GL/A-20:74 (12 Solsbury Cre., Glanbrook)

Consolidation Report

The attached comments have been reviewed with regard to the above noted Committee of Adjustment application and the following comments are submitted:

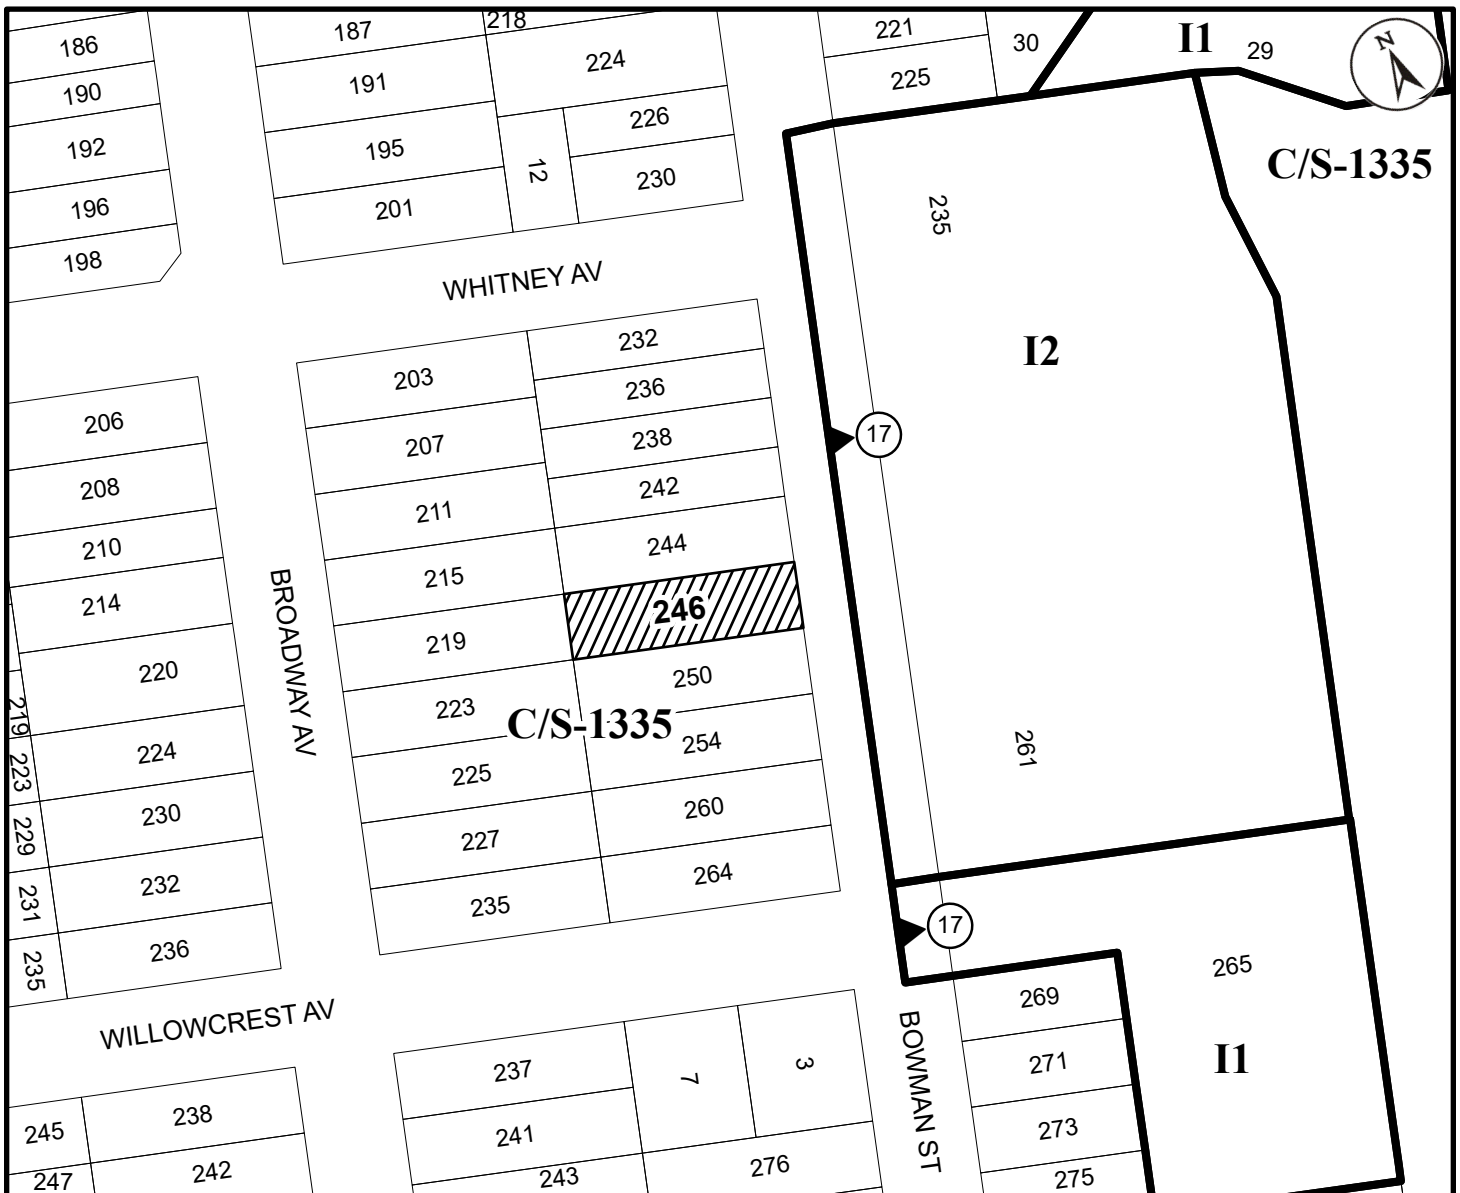
3. Drawing Numbers A3.01 and A4.01 attached to the Notice are not the most recent revised Plans submitted by the applicant. Further, Drawing Nos. A5.01, A6.01, A7.01 and A8.01 submitted by the applicant were not attached to the Notice.
4. The Applicant confirmed that the “garage” is intended for storage of residential items for the dwelling and is not used for the parking of vehicles.

5. The direction of the North sign shown on the Site Plan is incorrect and should be revised. North is to the top of the Site Plan as Bowman Street runs North/South.
6. The Ontario Building Code requires a clear height of 1.95m under beams and ducting in basement units.
7. Be advised that Ontario Building Code regulations may require specific setback and construction types.
8. The Ontario Building Code prohibits an unprotected opening in a building face adjacent to a side yard less than 1.2m in width.
9. Order to Comply [Folder Number 19-142353], dated August 20, 2019, is outstanding.
10. A building permit is required for construction of the porches and conversion of the single family dwelling to add an additional dwelling unit.
